Pentium® Pro Processor Specification Update

Release Date: October 1998

Order Number: 242689-032

The Pentium® Pro processor may contain design defects or errors known as errata which may cause the product to deviate from published specifications. Current characterized errata are documented in this Specification Update.

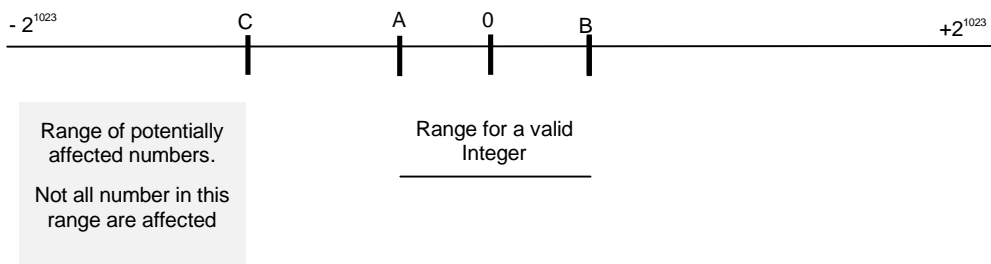
PROBLEM: On certain, large, negative, floating-point operands, and only in three of the four possible processor rounding modes, the instructions FIST[P] m16int and FIST[P] m32int do not detect that the operand is so large that it will not fit into the target data size. As a consequence, the expected Invalid Operation exception response for this situation is not correctly provided, nor is the Invalid Operation flag set in the Floating Point status word as specified in the *Intel Architecture Programmers Reference Manual, Volume 2*. Under the failing conditions, noted below, the precision exception (#PE) flag will also be incorrectly set. The erratum occurs only when all of the following conditions are met:

B. Expected Response

The expected processor response when the invalid operation exception is *masked* is:

- Return the MAXNEG value (8000h for FIST16 & 80000000h for FIST32) to memory.
- The IE (Invalid Operation) bit in the Floating Point status word is *set* to flag the overflow.
- The PE (precision error) bit the Floating Point status word is *not set*.

Figure 4-3. Stack Switch on a Call to a Different Privilege Level

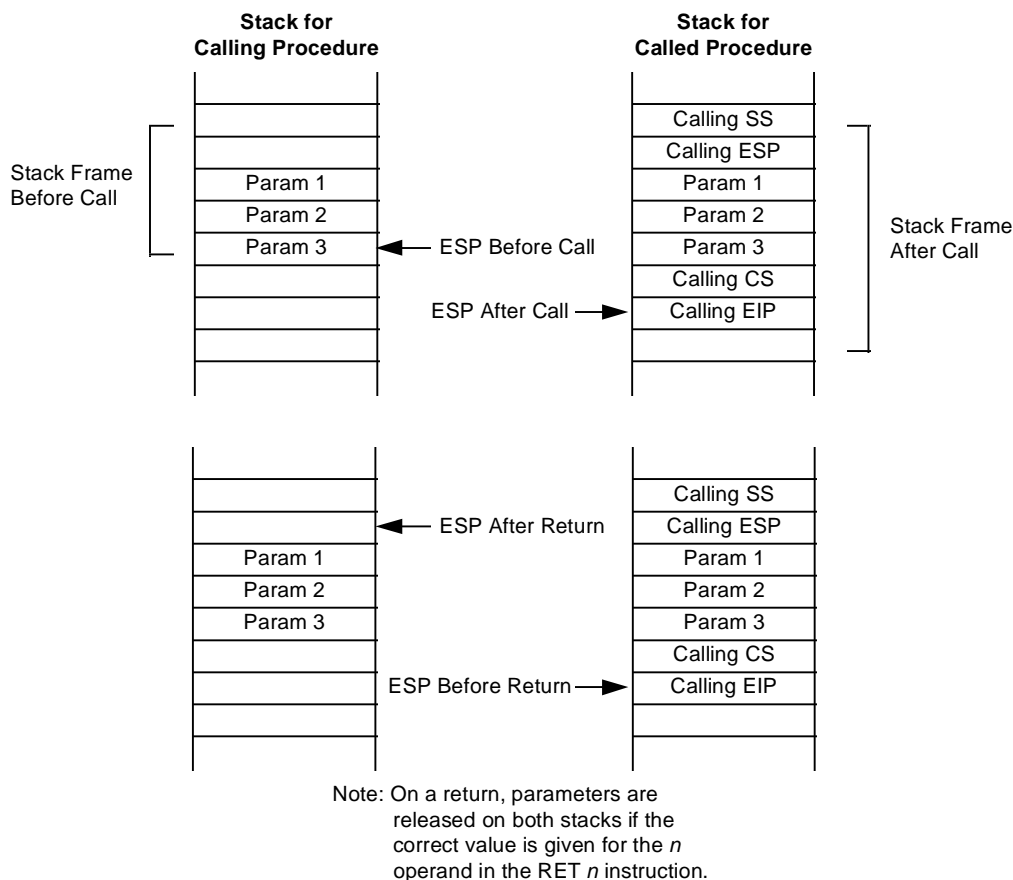
When making a call to a more privileged protection level, the processor does the following (see Figure 4-3):

4. Restores the SS and ESP registers to their values prior to the call, which causes a switch back to the stack of the calling procedure.
5. (If the RET instruction has an optional n argument.) Increments the stack pointer by the number of bytes specified with the n operand to release parameters from the stack (see explanation in step 3).

Figure 4-4. Stack Usage on Transfers to Interrupt and Exception Handling Routines

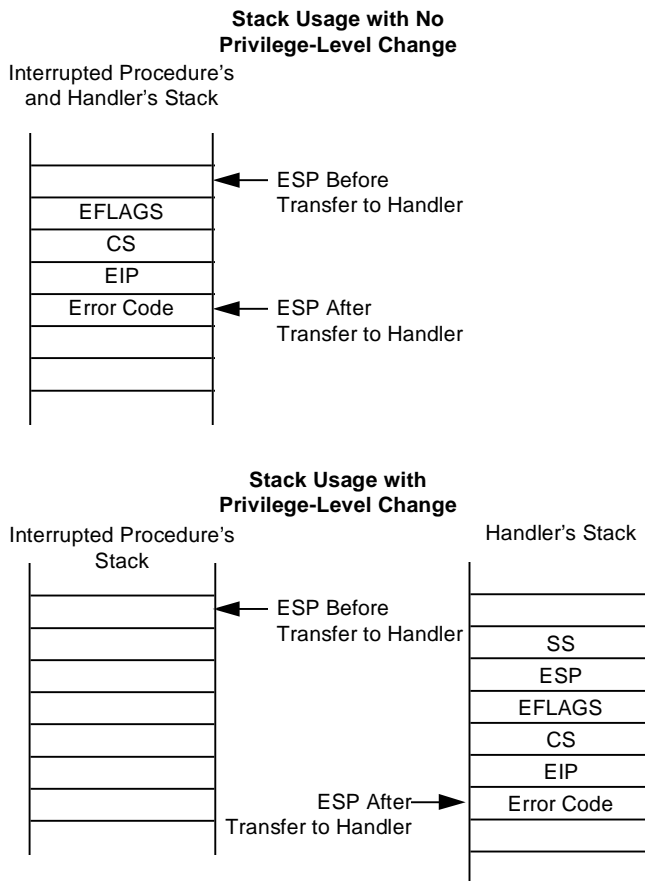
If no stack switch occurs, the processor does the following when calling an interrupt or exception handler (see Figure 44):

1. Performs a privilege check.
2. Restores the CS and EIP registers to their values prior to the interrupt or exception.
3. Restores the EFLAGS register.

4. Restores the SS and ESP registers to their values prior to the interrupt or exception, resulting in a stack switch back to the stack of the interrupted procedure.
5. Resumes execution of the interrupted procedure.
